1997 - 2002 Corvette: Service Bulletin: SMU - Revised Side Cover and Gasket Replacement (RH)/Differential Carrier Cover and Seal Replacement

Number: 02-04-20-003

Subject: SMU - Revised Side Cover and Gasket Replacement (RH)/Differential Carrier Cover and Seal Replacement - Right

Model Year: 1997-2002 Chevrolet Corvette

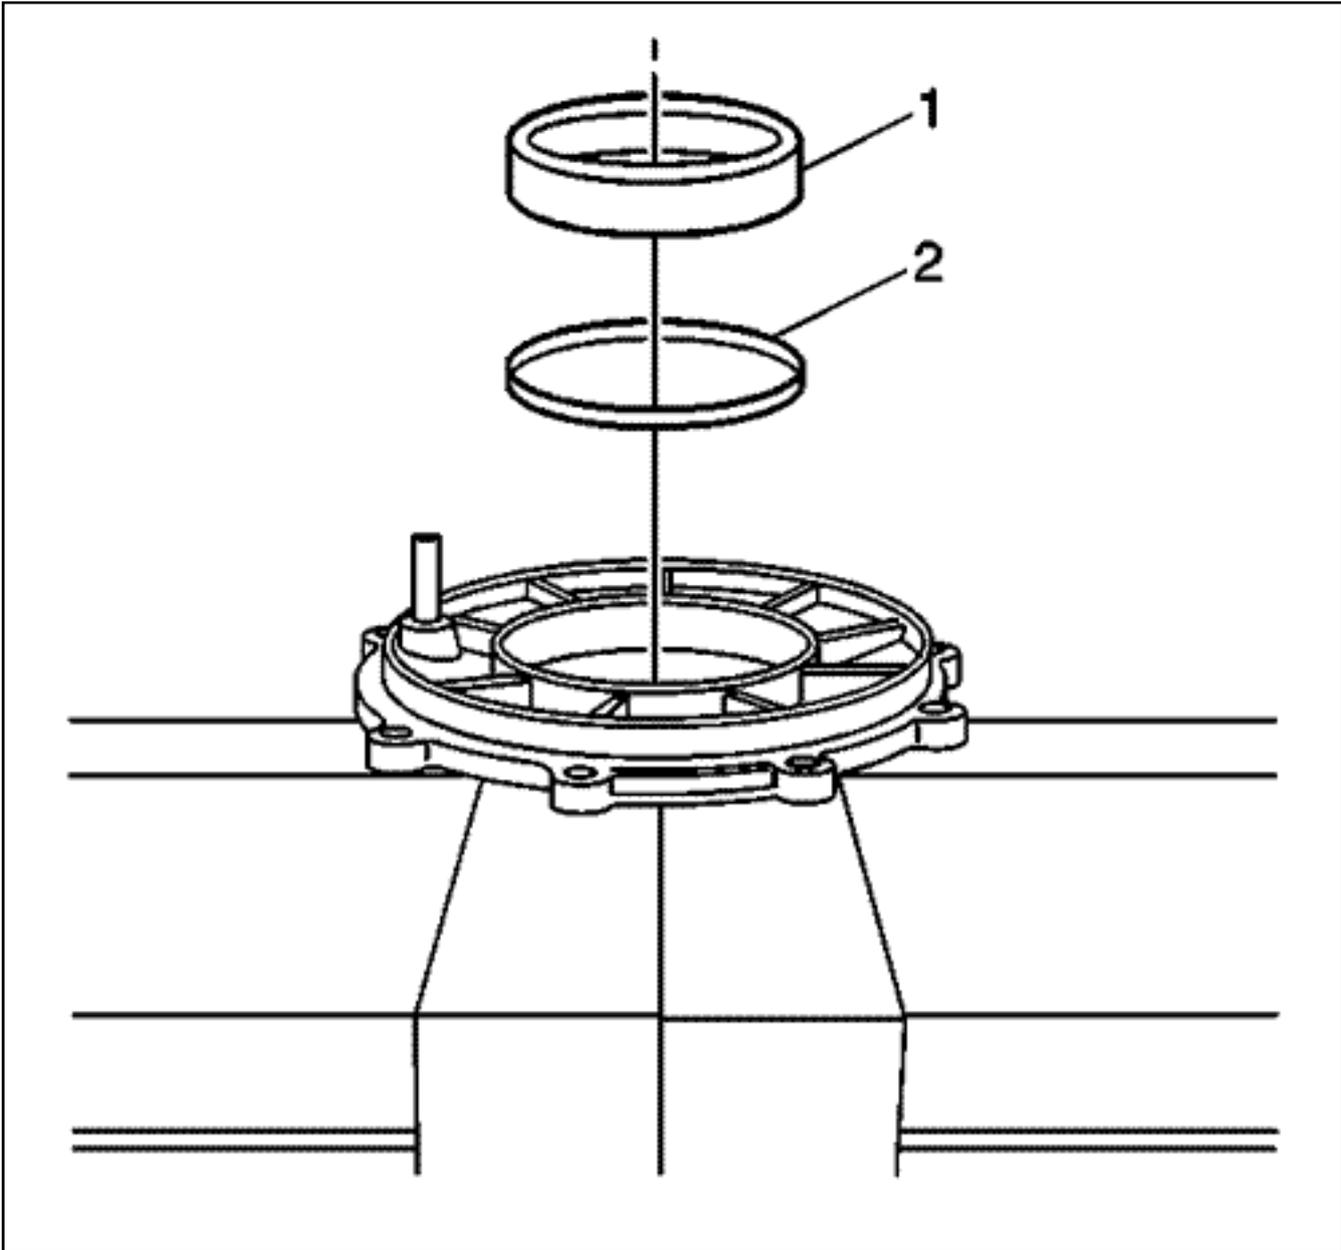
Whenever service requires the replacement of the right side differential cover, the covers MUST be measured and the right side shim pack adjusted to compensate for machining tolerances between the two components. Failure to perform this measurement procedure may result in improper differential bearing preload.

13. Use a caliper (2), a straight edge (1), and J 42168-16 (3) in order to measure the NEW differential cover bore dimension. Record the measurement as value A.
14. Use a caliper (2), a straight edge (1), and J 42168-16 (3) in order to measure the old differential cover bore dimension. Record the measurement as value B.
15. Subtract value B from value A. If the computation is a positive value, add shims equal to the value, to the existing shim pack. If the computation is a negative value, subtract shims equal to the value, from the existing shim pack.

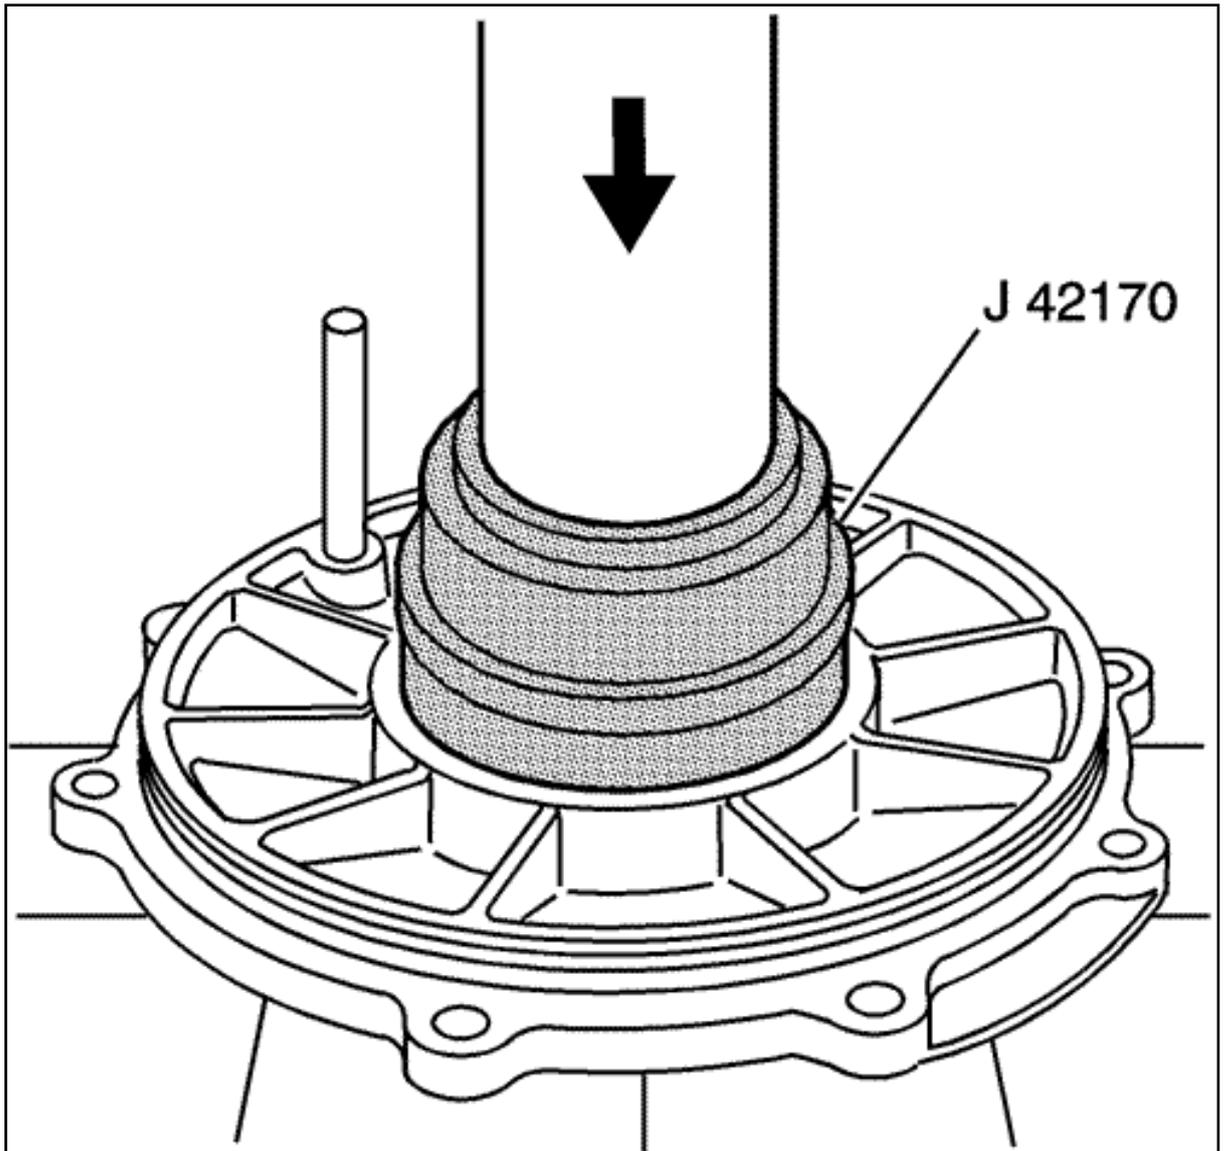
1. Install the selected shims (2) and the bearing race (1) to the NEW cover (right).

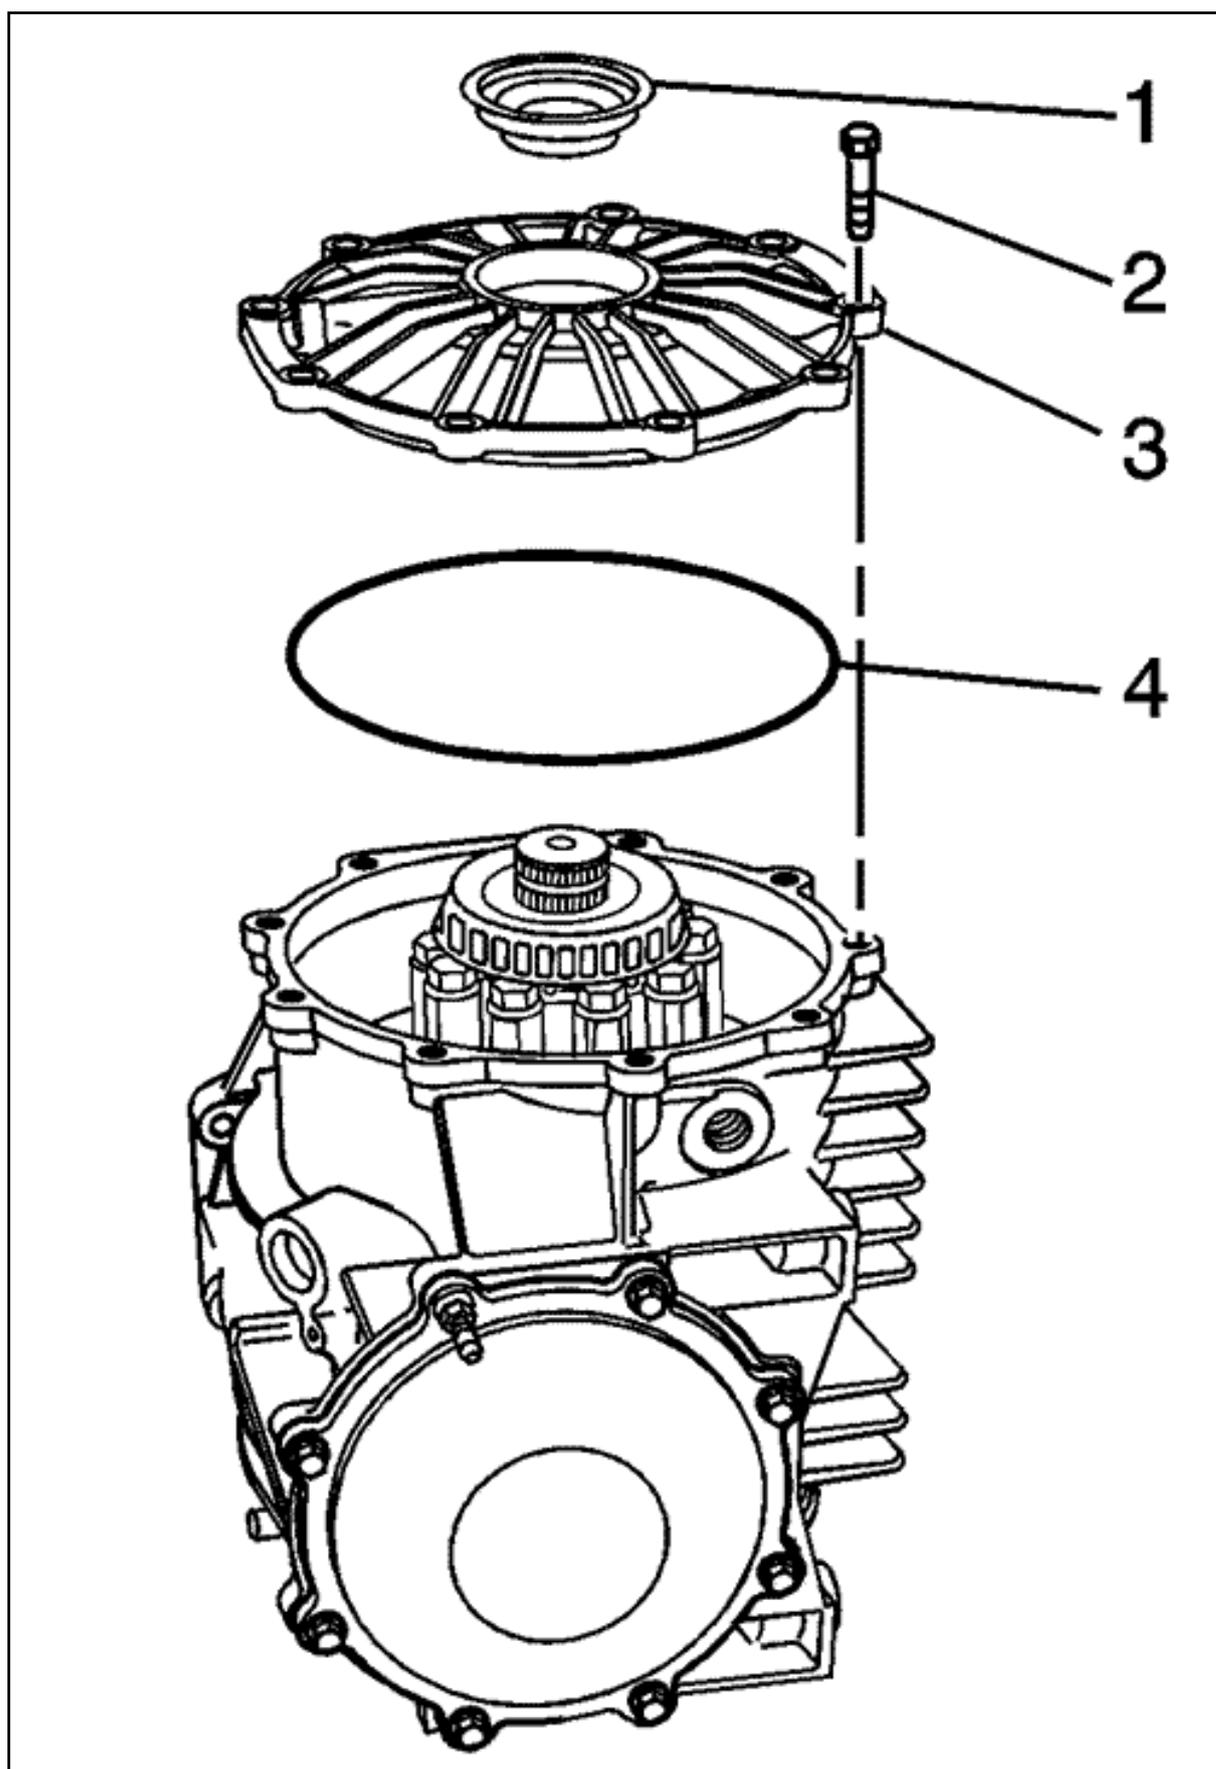
2. Press the shims and bearing race into the NEW cover (right) using the J 42170 and a hydraulic press.
